# 54 STATE STREET

ATELIER ARCHITECTURE 64

# LANDMARKS OBJECTIONS

1. CORNICE

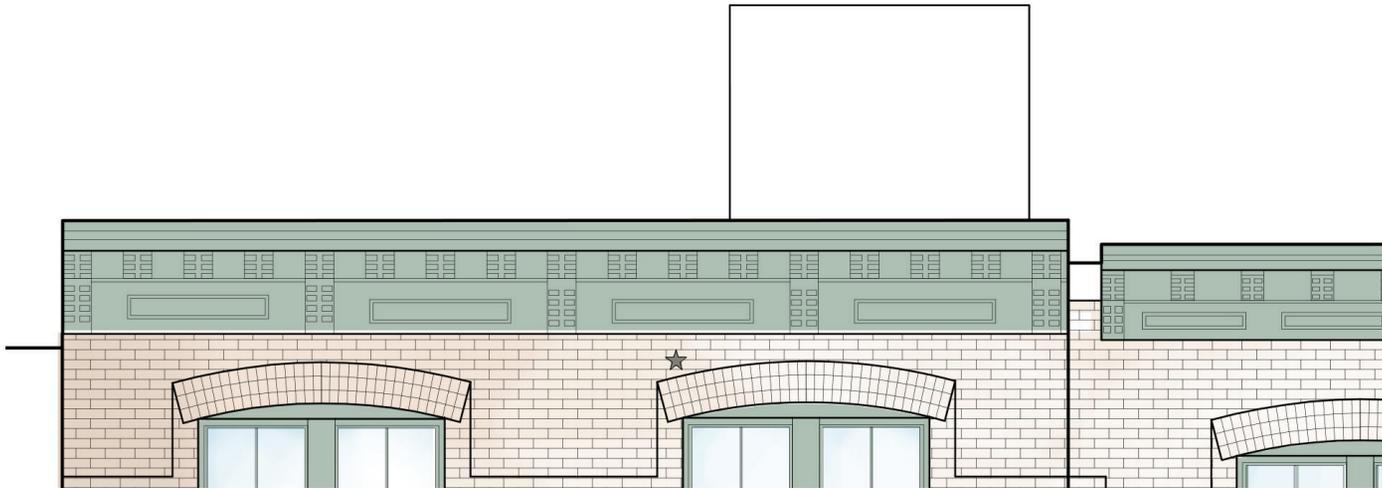
**VIOLATION:** CORNICE REPLACED WITHOUT APPROVAL

**PROPOSED:** LEGALIZE CORNICE AS EXISTING

2. WINDOW SILL (TYPICAL)

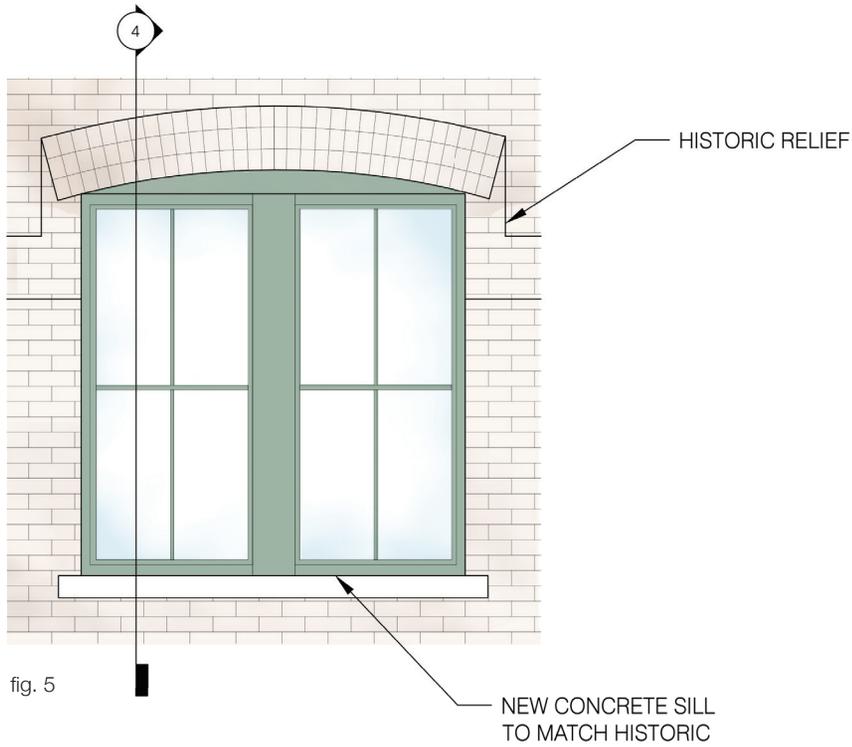
**VIOLATION:** WINDOWILLS REPLACED WITHOUT APPROVAL

**PROPOSED:** REPLACE EXISTING WINDOW SILL WITH NEW TO MATCH HISTORIC

3. RAILING

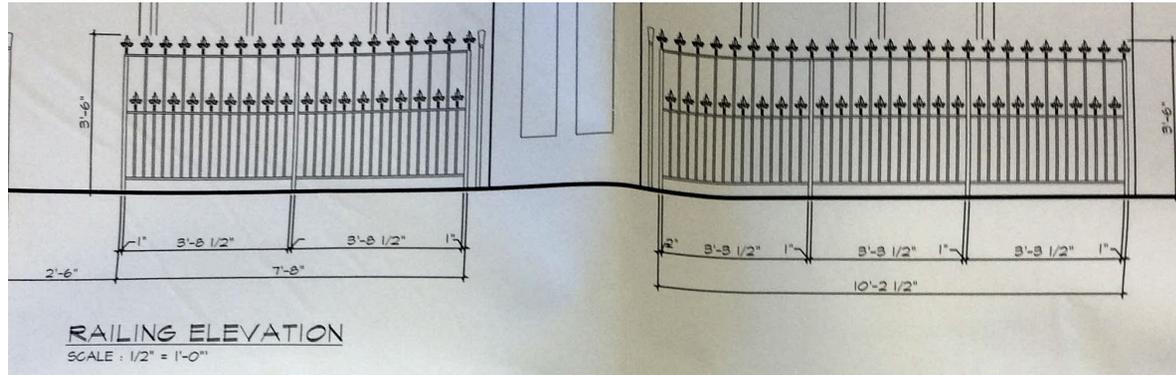
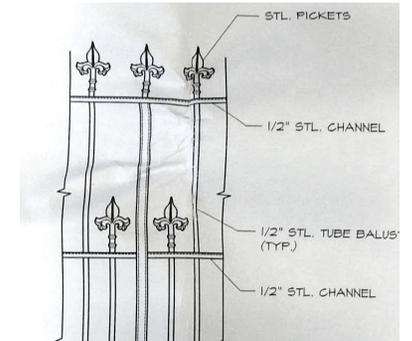
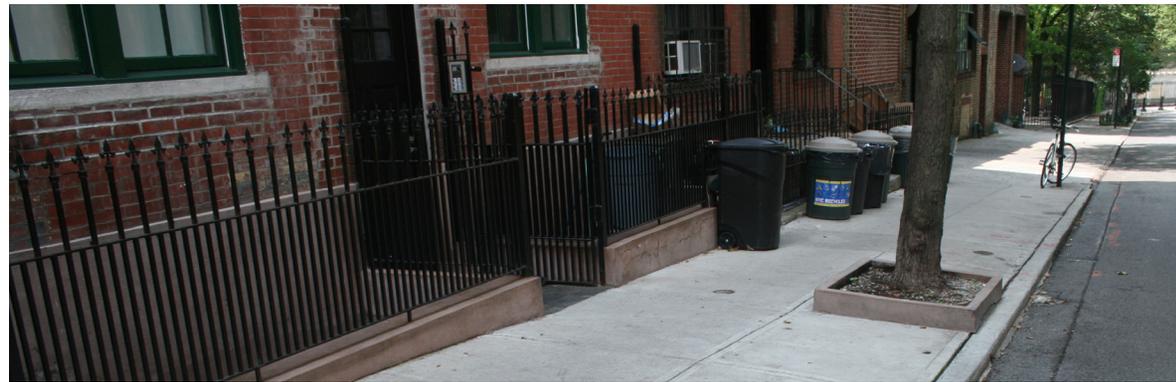
**VIOLATION:** RAILING REPLACED WITHOUT APPROVAL

**PROPOSED:** SHORTEN RAILING TO 36", REPLACE CAPS WITH EXISTING

4. STUCCO

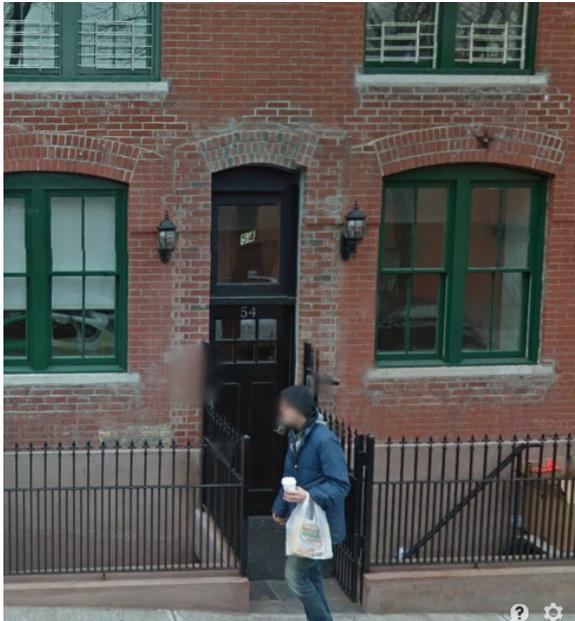
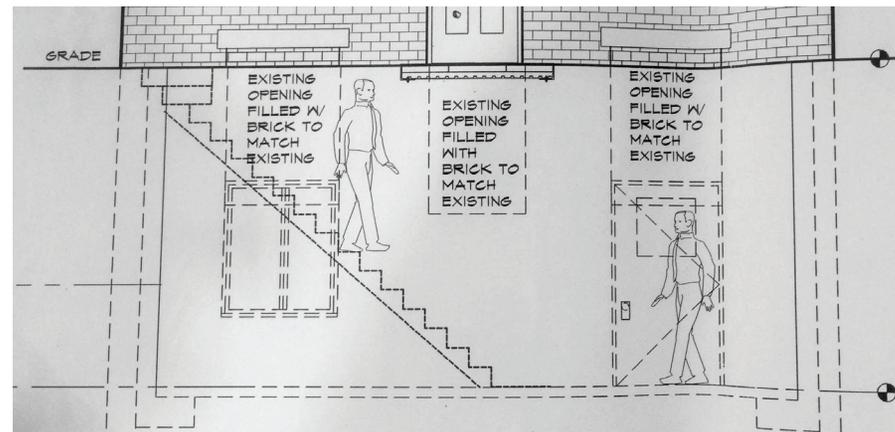
**VIOLATION:** STUCCO APPLIED WITHOUT APPROVAL, LOCATION OF DOOR AND STAIRS DIFFER FROM APPROVED DRAWINGS

**PROPOSED:** LEGALIZE STUCCO, DOOR AND STAIRS AS EXISTING

PROPOSED ENTRY PLAN

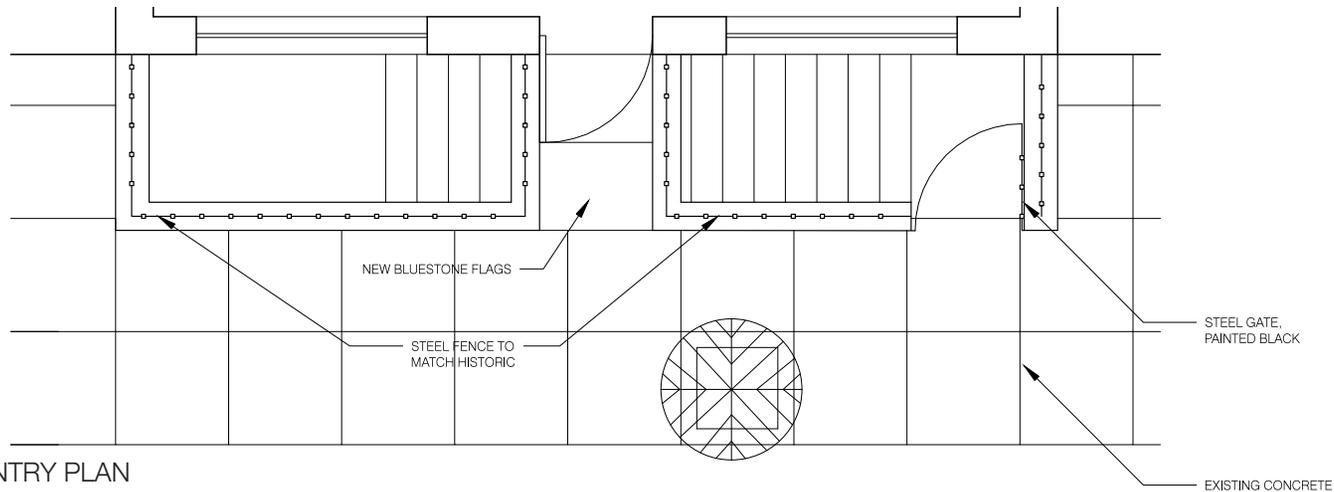
**VIOLATION:** TILE INSTALLED CONTRARY TO APPROVED PLANS

**PROPOSED:** REPLACE EXISTING TILE WITH BLUESTONE FLAGS

EXISTING SIDEWALK

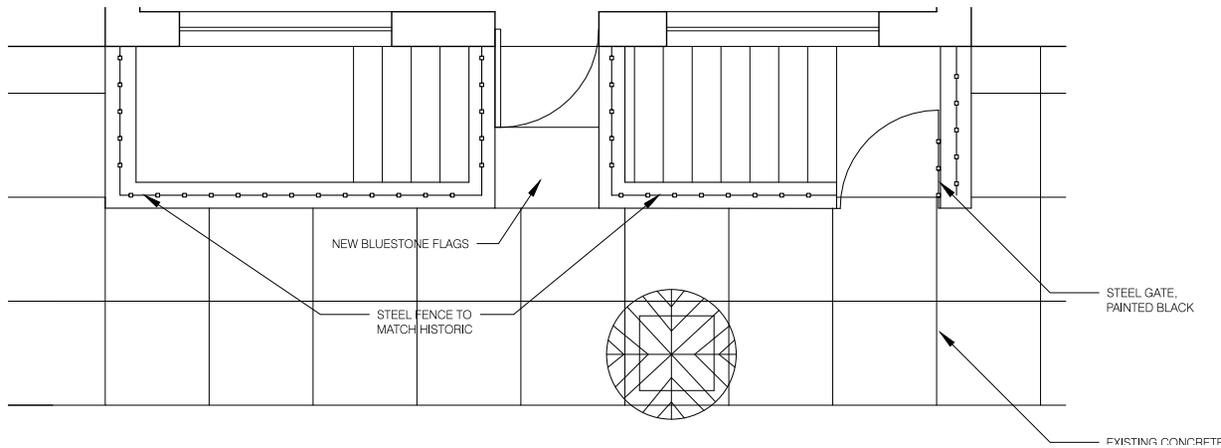
**VIOLATION:** CONCRETE FLAGS INSTALLED CONTRARY TO APPROVED DRAWINGS

**PROPOSED:** LEGALIZE REPLACEMENT OF BLUESTONE FLAGS (AS APPROVED) WITH CONCRETE

VIEW FROM WILLOW PLACE DURING  
CONSTRUCTION

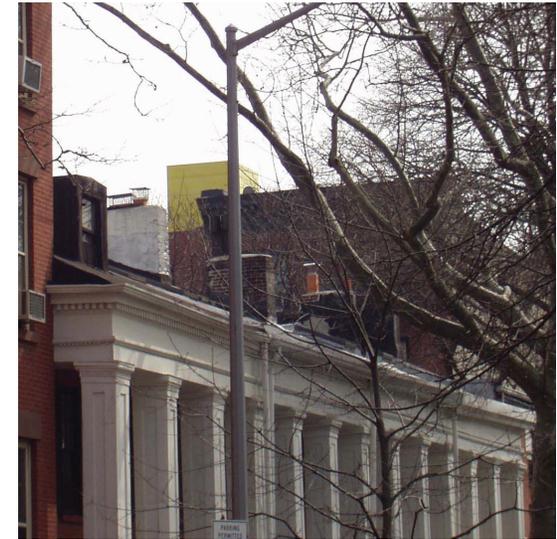
**VIOLATION:** ELEVATOR BULKHEAD AND PARAPET BUILT WITHOUT APPROVAL

**PROPOSED:** LEGALIZE HEIGHT OF EXISTING BULKHEAD AND PARAPET

CONDENSER UNITS, VIEWED FROM ATLANTIC AVE

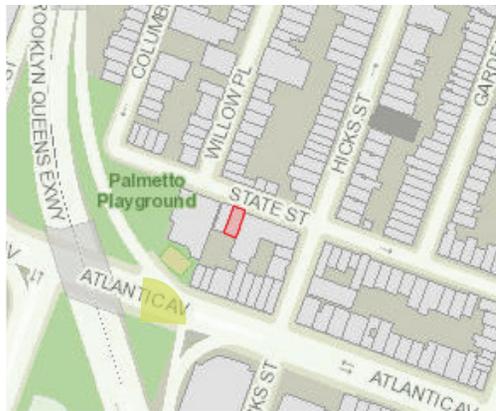
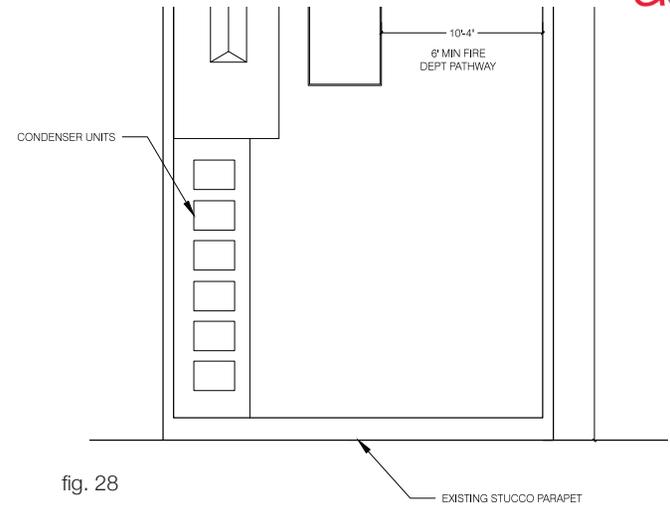
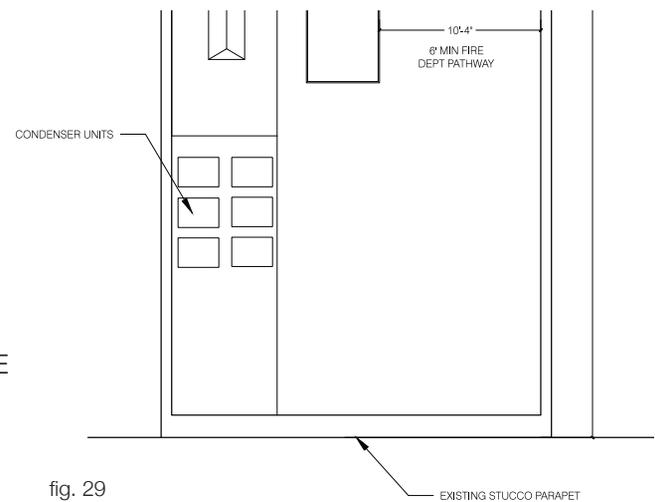
**VIOLATION:** CONDENSER UNITS INSTALLED ON ROOF ARE VISIBLE FROM ATLANTIC AVENUE

**PROPOSED:** MOVE THREE OF THE SIX UNITS SO THAT THEY ARE LESS VISIBLE FROM THE STREET.

EXISTING FRONT DOOR

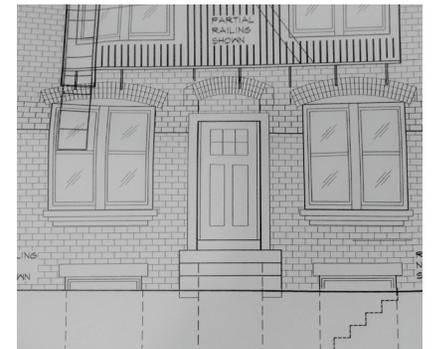
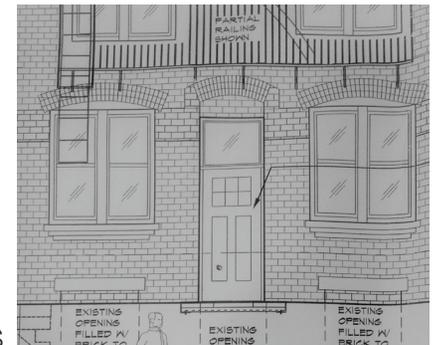
**VIOLATION:** STUCCO APPLIED AROUND FRONT DOOR AND THEN REMOVED AND REPLACED WITH BRICK NOT MATCHING HISTORIC. INTERCOM INSTALLED WITHOUT APPROVAL.

**PROPOSED:** REPLACE BRICK SURROUNDING FRONT DOOR TO MATCH HISTORIC. RELOCATE CONDUIT FOR INTERCOM TO RUN UP ALONG RAILING.
